ENVIRONMENTAL

REVIEW TEAM

REPORT

Arrowhead II

ARROWHEAD II SUBDIVISION
Preliminary Site Plan
Not To Scale

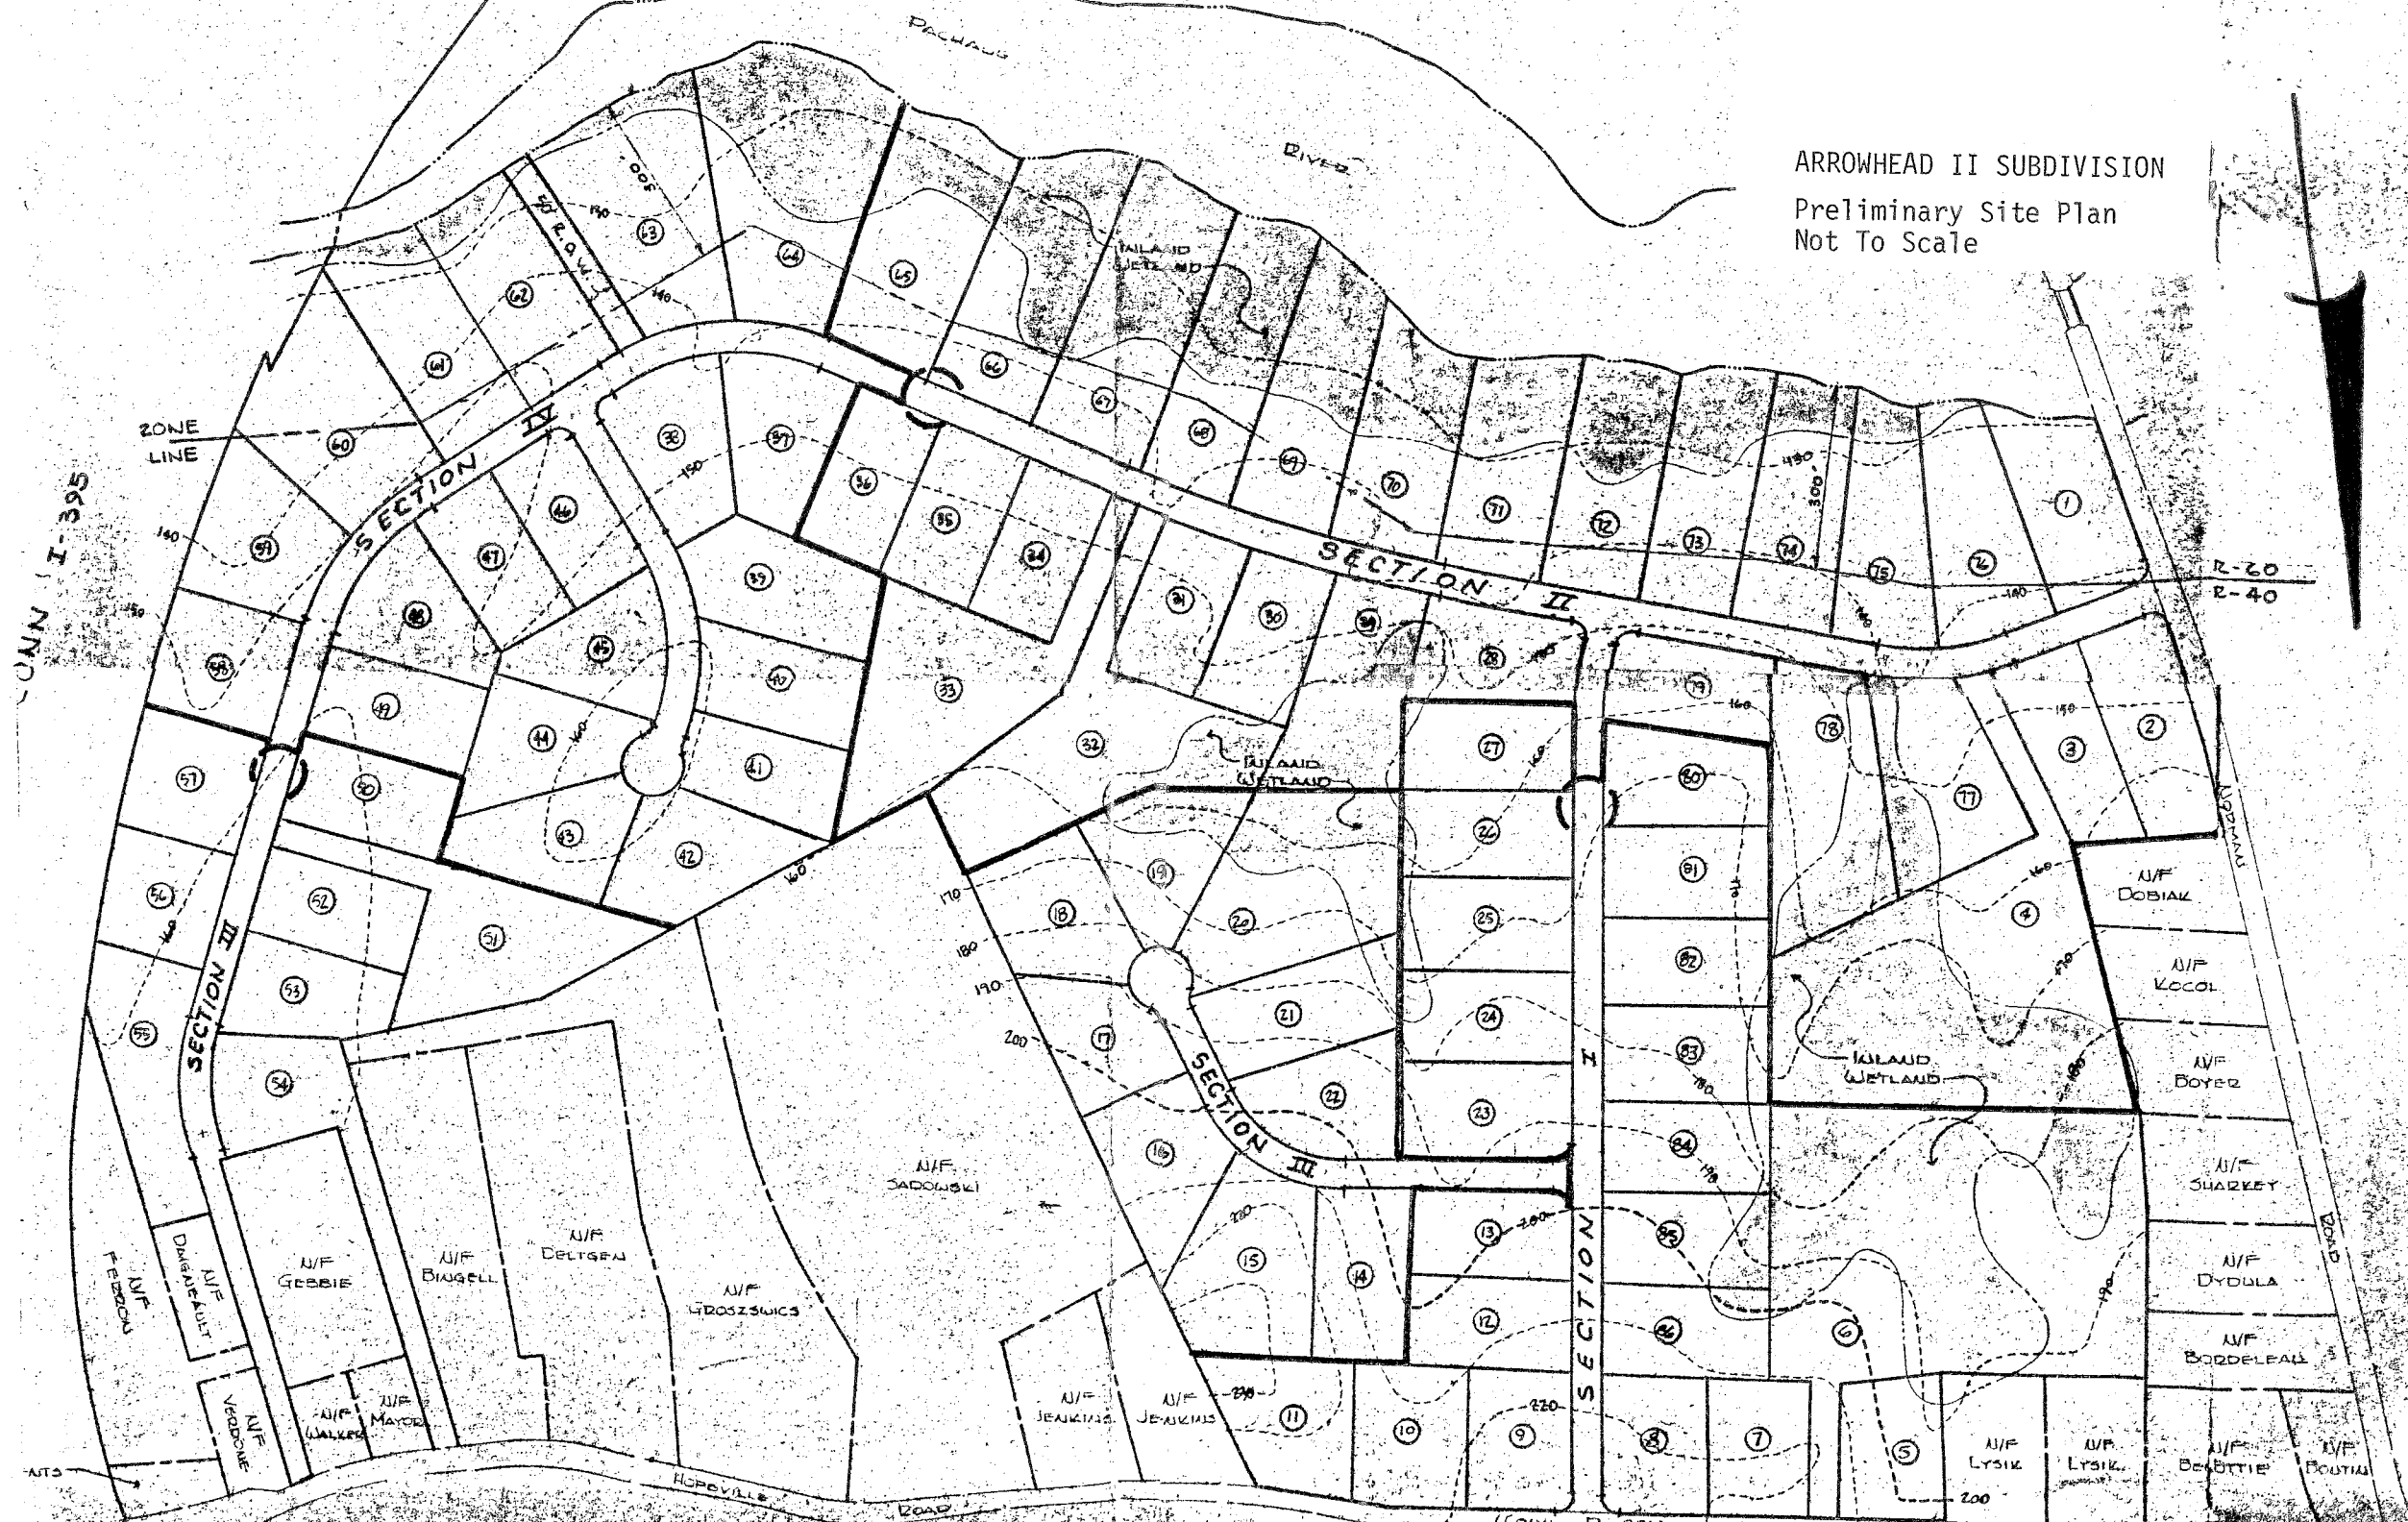
Based on an air photo taken on April 17, 1980, a ± 7 acre oval-shaped wetland area covers a cornfield in the southern parts of the site. This wetland was not delineated on the preliminary subdivision plans for Arrowhead II (dated July 1985) which was distributed to team members on the review day. A revised preliminary plan dated December 7, 1985 which was mailed to the Team's Geologist December 26, 1985 shows the wetland, but it does not appear to be as extensive as the wet area visible on the air photo mentioned earlier.

Based on the site plan submitted to team members on the review day, and the revised plan dated 12/7/85, inland-wetland soils on the site will need to be crossed in order to construct the proposed interior road system, and depending on desired house locations, driveways may need to cross wetland soils also. Although undesirable, wetland road crossings are feasible provided they are properly engineered. The road should be constructed adequately above the surface elevation of the wetlands. This will allow for better drainage of the road and also decrease the frost heaving potential of the road. Road construction through wetlands should preferably be done during the dry time of the year, and should include provisions for effective erosion and sediment control. Finally, culvert(s) should be properly sized and located so as not to alter the water levels in the wetland or cause flooding problems.

Although proposed lots for the subdivision would be quite large considering the use of public water, there are also a number of adverse or limiting factors which need to be recognized and taken fully into account. Most likely the overall number of proposed lots would or should be reduced in order to provide for a more assured, viable layout.
